HYNES ELEMENTARY SCHOOL BUILDING ADDITIONS  
 GOLF SCHOOL DISTRICT 67  
 9000 BELLEFORTE AVENUE  
 MORTON GROVE, IL 60053

**PLAN COMMISSION REPORT FOR PC 25-07**

## STAFF REPORT

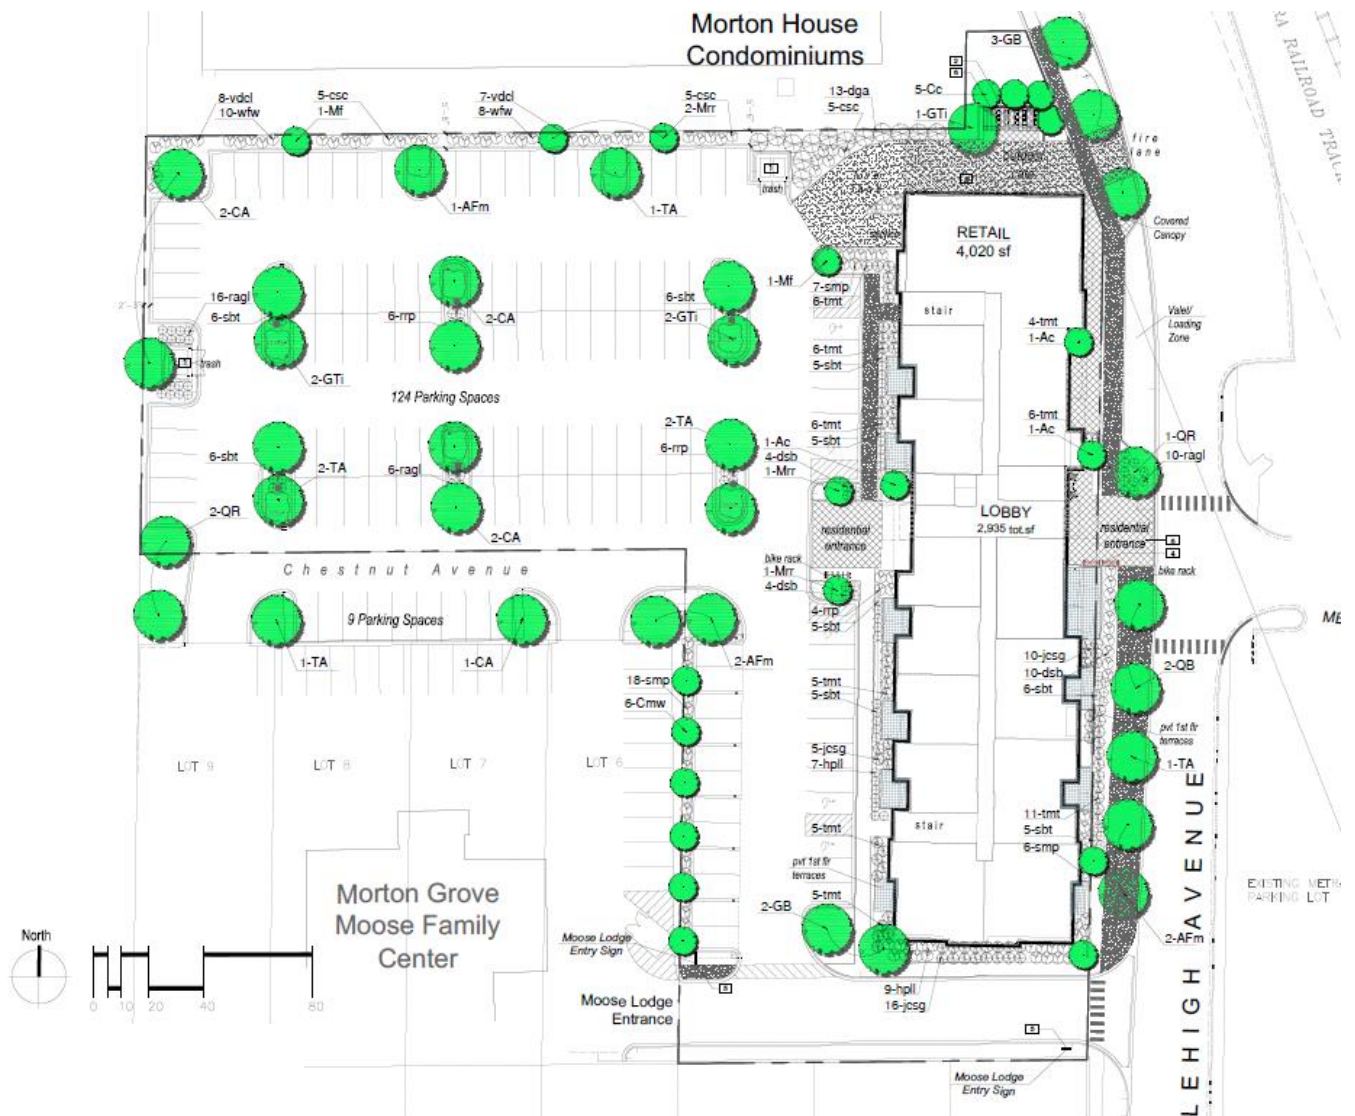
Nine new street trees are proposed along Lehigh Avenue. Staff is concerned that additional trees within the public right of way will conflict with valet /loading zone that will be desirable for potential future restaurant operations at the project, and is supportive of the waiver of one tree. With respect to the proposed waiver to allow no landscaping or alternative screening along lot lines abutting forest preserve property, staff recommends reducing the minimum screening height to three feet, where five feet are typically required by Code, or as otherwise recommended by Forest Preserve District staff. Staff is concerned that headlights from vehicles in the parking and driveway areas will be disturbing to these biologically sensitive areas and should be shielded. *With the condition of approval recommended by Staff, the developer may install fencing or year-round opaque screening a minimum of three feet in height. Staff also recommends that any landscape installation along lot lines abutting the forest preserves must be limited to native species.*

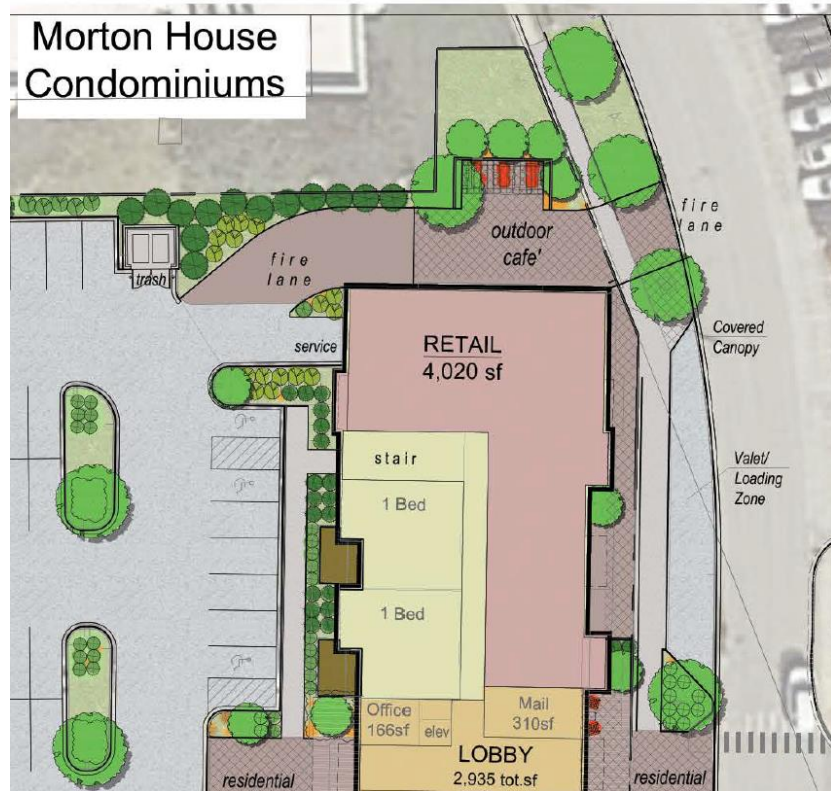
The applicant should confirm the potential locations of future outdoor seating and speak to what kind of protections and screening will be provided for diners within the outdoor seating areas in the Lehigh Avenue public right of way.

Staff recommends that as a condition of Appearance Certificate approval, all final outdoor seating area plans, including screening and furniture specifications, must be reviewed and approved by the Appearance Commission Chairperson. The Chairperson may require full Appearance Commission review if the quality and design of the outdoor seating areas is not in keeping with the quality and design of the overall development. Language regarding planter box maintenance is also included as a condition.

Proposed Site Plan

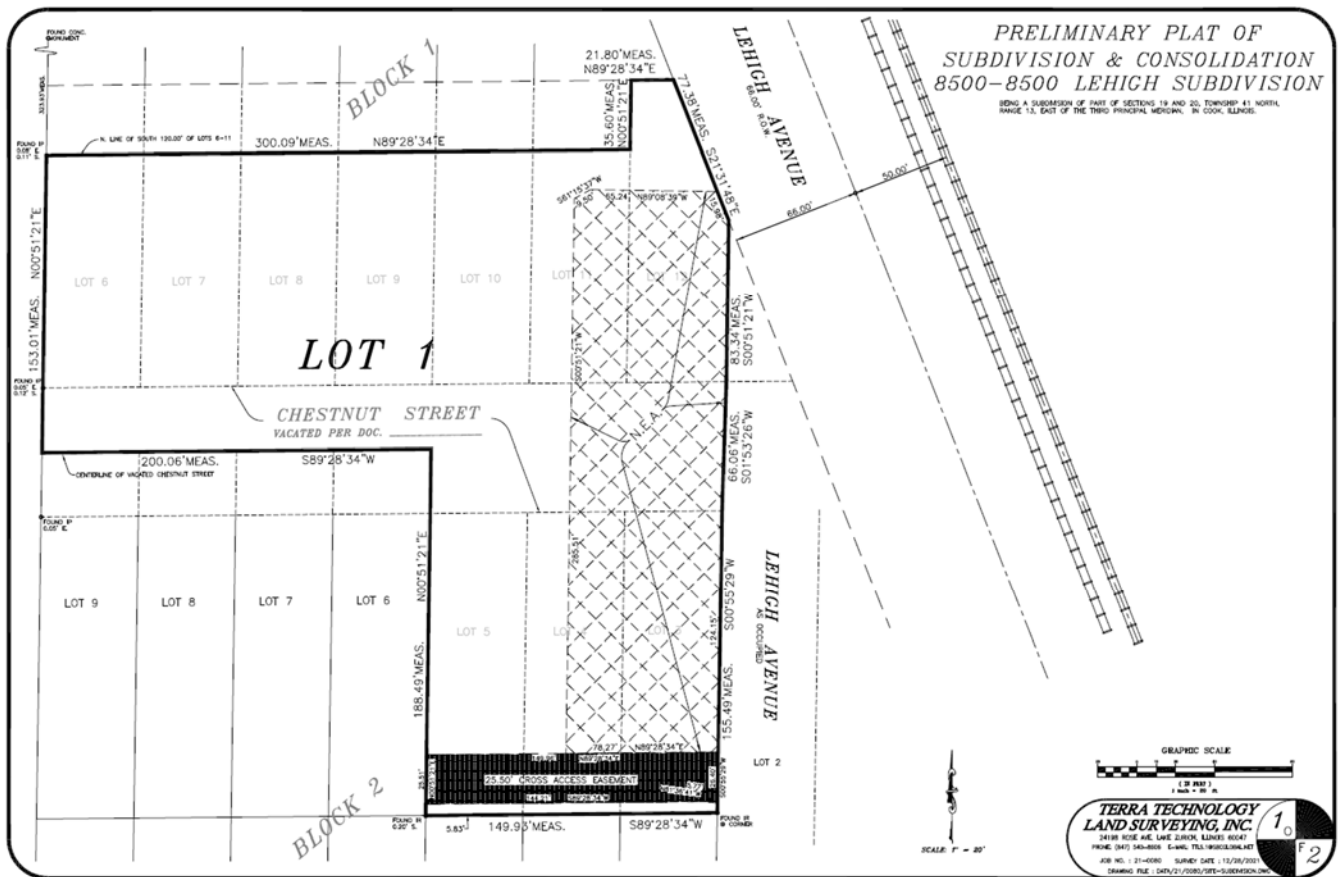
The proposed site plan provides a setback of between 4.1 feet and 5.9 feet at the front lot line along much of Lehigh Avenue creating a strong streetwall. The development's surface parking will be located to the rear of the principal structures and out of view from Lehigh Avenue, so as not to disrupt the pedestrian nature of the streetwall. The use of a singular public vehicular accessway creates a continuity in the streetwall. Recessed balcony areas with small patios on the ground floor and related changes in material break up the façade. A large central building entrance, ground floor residential patios, and a high degree of transparency provided by large ground floor windows will also help provide for a sense of activity at the street level. Landscaping areas along the buildings' frontage and new street trees will also contribute to a vibrant and pedestrian-oriented public realm. The northern side setback will be heavily landscaped to provide buffering between the Morton House Condominiums, an abutting multi-family residential use to the north, and maintain visual interest along Lehigh Avenue.

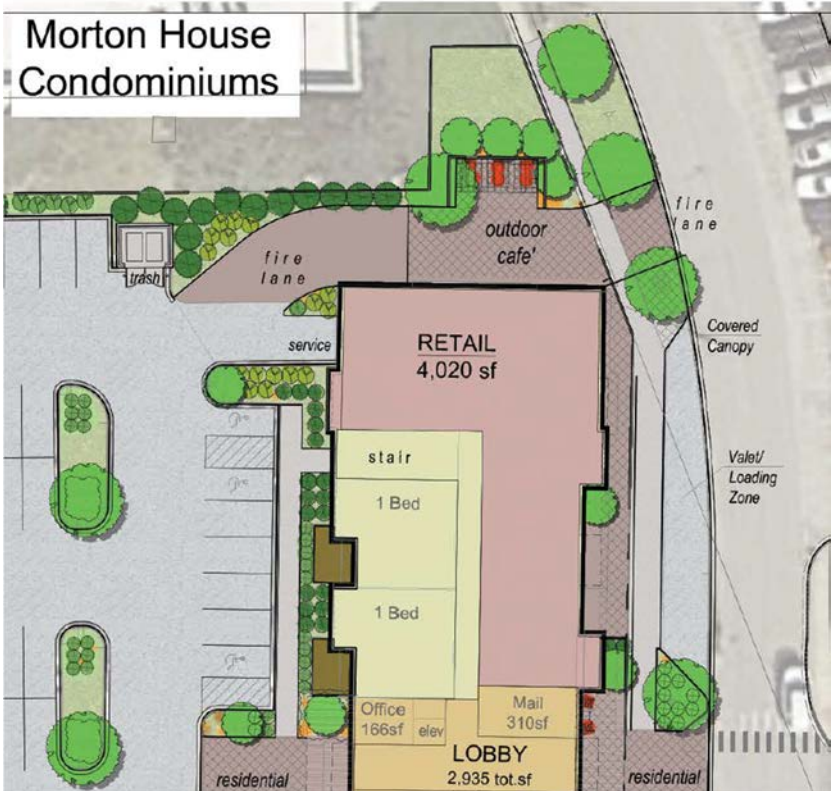
***The applicant should confirm the potential locations of future outdoor seating and speak to what kind of protections and screening will be provided for diners within the outdoor seating areas in the Lehigh Avenue public right of way.***

Staff recommends that as a condition of approval, all final outdoor seating area plans, including screening and furniture specifications, must be reviewed and approved by the Appearance Commission Chairperson. The Chairperson may require full Appearance Commission review if the quality and design of the outdoor seating areas is not in keeping with the quality and design of the overall development. Language regarding planter box maintenance is also included as a condition.

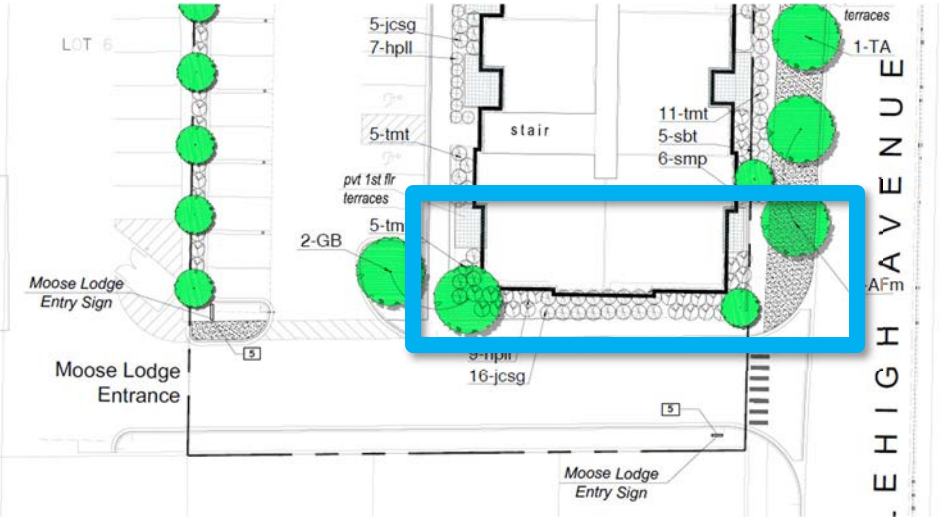
The site plan and landscape plan and related architectural drawings were revised by the applicant to eliminate a retail space and related outdoor seating area at the south end of the building. Staff has request revised civil drawings that replace the previous, outdated building extent and landscaping.

The sidewalk on the south side of the access drive along the south property line was also removed in the current application.
